ESP32-C3-WROOM-02-N4 / C2934560

QUALIFICATION BLOCKED — SUPPLIER VARIATION NOT APPROVED

Espressif v1.7, Figure 11-1 p38; preserved EasyEDA package ab901810668e4ba2b431728512d738d6

Outer contact, same-centre dimension overlay

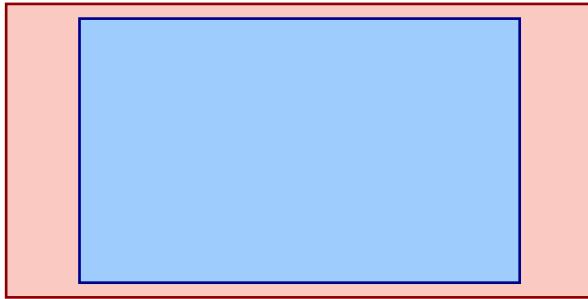
Supplier: 1.999996 x 0.999998 mm

Espressif recommendation: 1.5 x 0.9 mm

All 18 outer contacts have the same discrepancy.

Nine EP ground tiles agree: 0.7 x 0.7 mm.

The manufacturer specifies recommended lands, not a tolerance envelope. No failure tolerance is invented.

Faithful supplier import does not establish manufacturer approval of the larger copper/paste pattern.
